## RESPONSE TO REQUEST FOR ADDITIONAL INFORMATION

### US-APWR Design Certification

Docket No.52-021

**RAI NO.:** NO.589-4536 REVISION 2  
**SRP SECTION:** 03.11 – Environmental Qualification of Mechanical and Electrical Equipment  
**APPLICATION SECTION:** 3.11  
**DATE OF RAI ISSUE:** 6/8/2010

**Figure E-1 Calculation Flow of Accident Dose Rate inside the Containment**

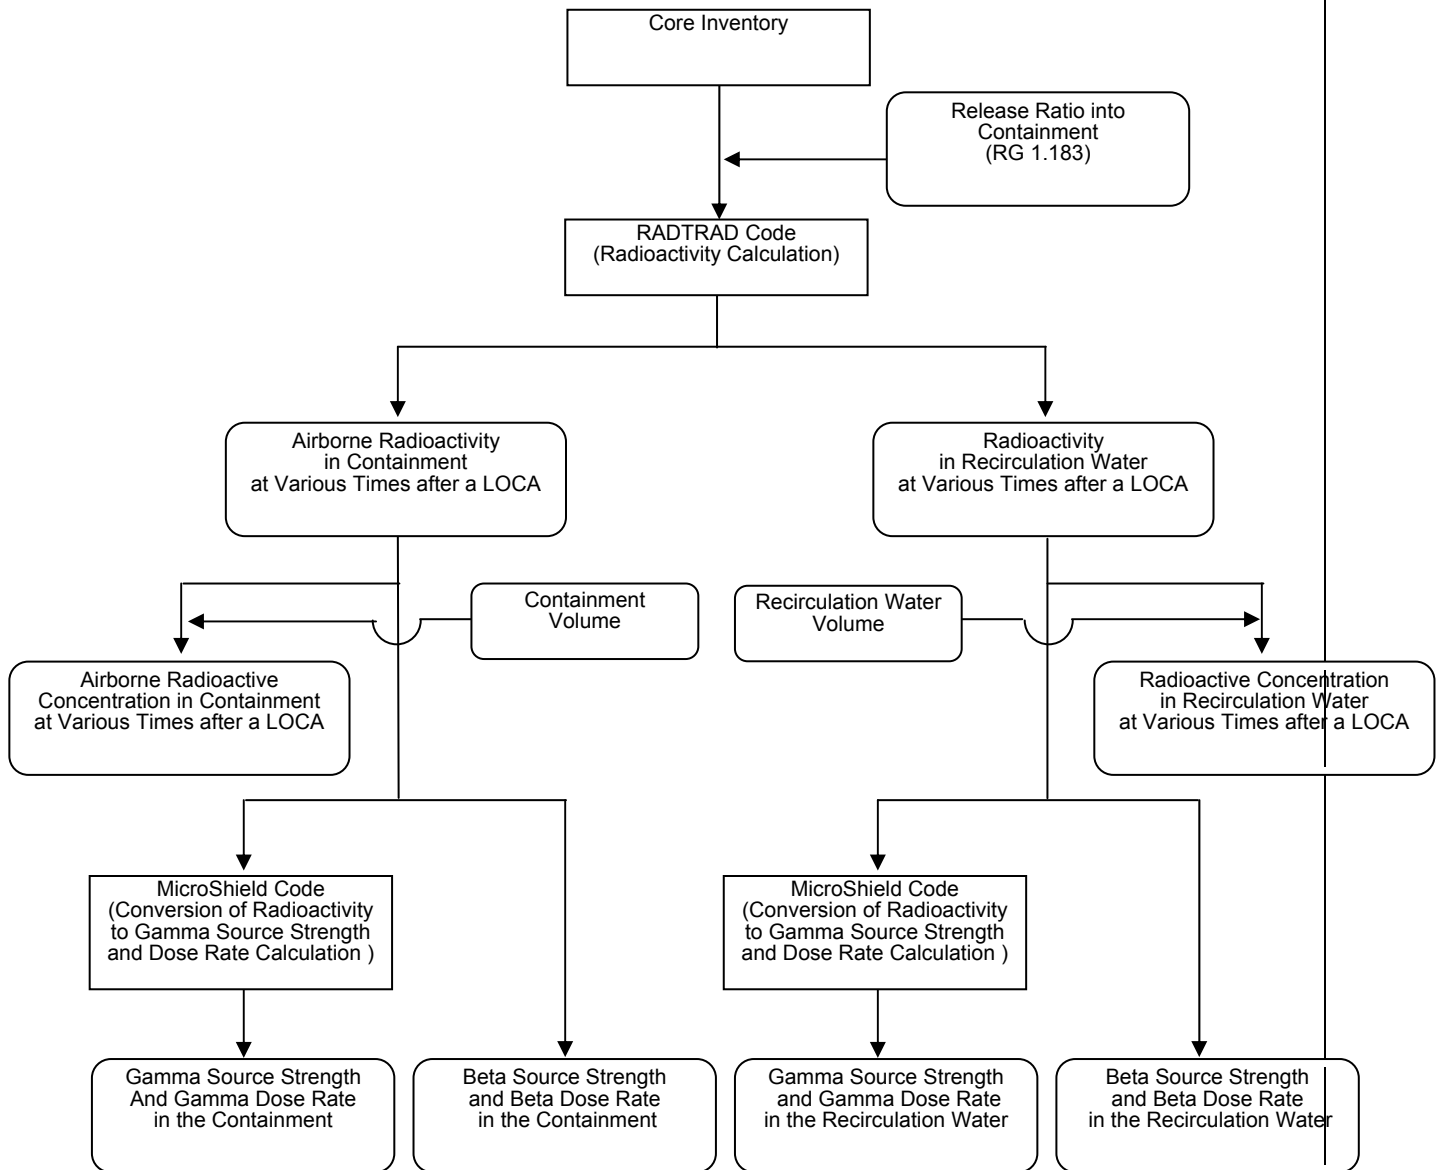
Question RAI 512-3893 03.11-29, requested additional information, beyond that provided in the response to RAI 358-2642 Question 03.11-1, about the methodology and assumptions used to calculate the Total Integrated Dose (TID) to equipment. In their response, the applicant provided a more detailed narrative description of the method used to establish the source term. The applicant also provided a general formula for calculating beta dose rates in water and air. However the response did not include the MicroShield input parameter data files and insufficient information was available to the NRC staff to allow confirmation of the TID values provided in MUAP-08015 Revision 1, Table 5-5 "Total Integrated Dose for Zone". In addition, the applicant did not justify the use of analytical methods that are not consistent with the guidance provided in Regulatory Guide 1.183 "Alternative Radiological Source Terms for Evaluating Design Basis Accidents at Nuclear Power Reactors". Examples of inconsistency include the omission of information regarding about how the contribution from the decay chains of the principle radio nuclides are considered, how gamma and beta TID was calculated for points located on the surface of the water at the centerline of the large pool of sump water and the effects of activity plated out on containment surfaces on TID. Also, in their response, the applicant referenced NISTIR 5632 "Tables Of X-Ray Mass Attenuation Coefficients and Mass Energy Absorption Coefficients for 1 keV To 20 MeV for Elements Z = 1 To 92 and 48 Additional Substances of Dosimetric Interest" (NISTIR-5632) and Federal Guidance Report 12 "External Exposure To Radio nuclides In Air, Water, And Soil" (FGR-12), that are not described in MUAP-08015 Revision 1, FSAR Revision 2 Tier 2 Sections 3.11 or FSAR Revision 2 Tier 2 Chapter 15 "Transient and Accident Analyses".

- Describe any computer codes, including revisions, besides MicroShield, that were used to calculate dose rates and the resultant Total Integrated Dose (TID) to equipment,
- Provide a sample calculation performed by the applicant to calculated dose rates and the resultant TID resulting from liquids, plated out material and airborne activity, including the input parameter and output data files of MicroShield and any other computer codes used for the analysis.
- Describe the basis for any assumed parameters, such as the Geometry Correction Factor, or the type of surface selected to represent a plate outsource.

The following is the method we used to calculate the doses to equipment (inside and outside containment, immersed in sump fluids) after LOCA. Calculation flow of accident dose rate inside the containment shows Figure E-1.
